Project	IEEE 802.16 Broadband Wireless Access Working Group < http://ieee802.org/16 >	
Title	Restructuring and Renaming of Management -Primitives in section 14.2.9	
Date Submitted	2006-05-05	
Source(s)	Jaesun Cha	jscha@etri.re.kr
	ETRI	
	Ronal Mao	rmao@huawei.com
	Huawei Technologies Co., Ltd.	
	Ronny (Yong-Ho) Kim	ronnykim@lge.com
	LG Electronics, Inc.	
Re:	Contribution on comments to IEEE 802.16g/D2	
Abstract	In this contribution, we propose to define some primitives for Neighbor BS Management.	
Purpose	Adoption	
Notice	This document has been prepared to assist IEEE 802.16. It is offered as a basis for discussion and is not binding on the contributing individual(s) or organization(s). The material in this document is subject to change in form and content after further study. The contributor(s) reserve(s) the right to add, amend or withdraw material contained herein.	
Release	The contributor grants a free, irrevocable license to the IEEE to incorporate text contained in this contribution, and any modifications thereof, in the creation of an IEEE Standards publication; to copyright in the IEEE's name any IEEE Standards publication even though it may include portions of this contrib

Figure 508 – ~~The use of Neighbor Advertisement Indication~~ Neighbor Advertisement Primitives

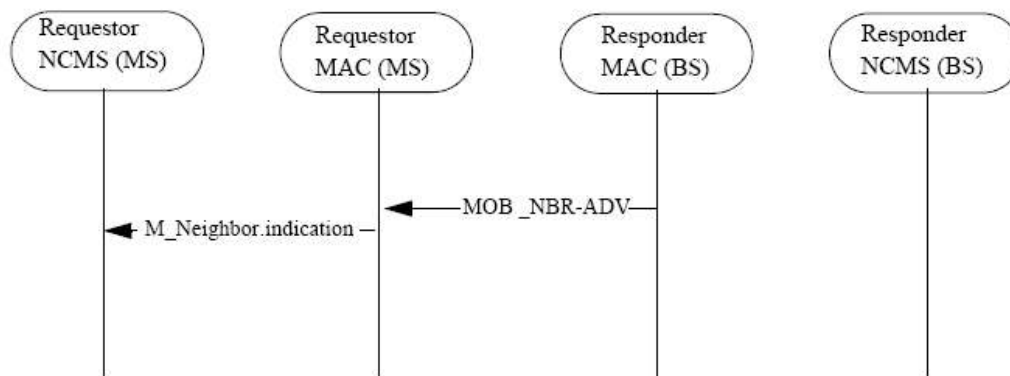
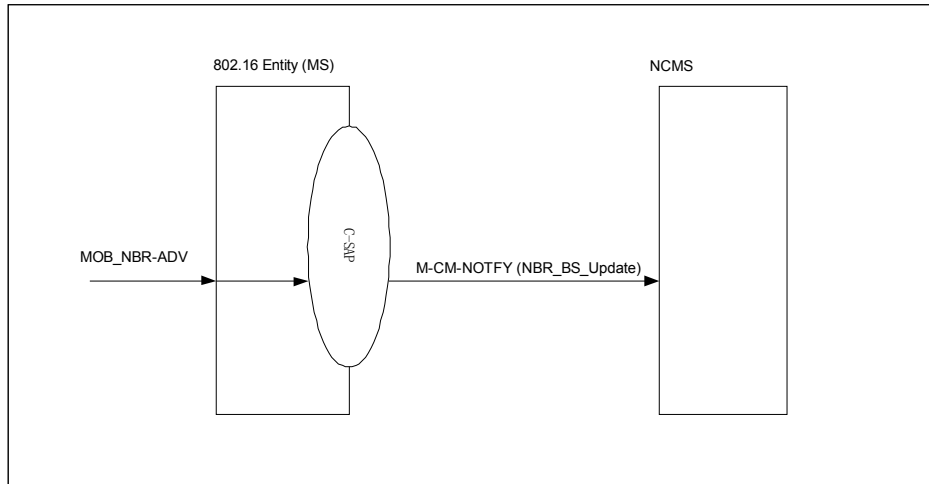
[Modify section 14.2.9.3 as follows and move it to the end of section 14.2.1.3.1.2.2]

~~14.2.1.4~~14.2.1.3.1.2.3 ~~Neighbor C-CM-NOTFY Advertisement Primitives~~ ~~M_Neighbor.indication~~

When 802.16 MAC receives neighbor advertisement (MOB_NBR-ADV), this primitive is used to deliver the information to upper layers.

14.2.9.3.1 ~~M_Neighbor.indication~~ M-CM-NOTFY

~~M_Neighbor.indication~~ M-CM-NEM-NOTFY
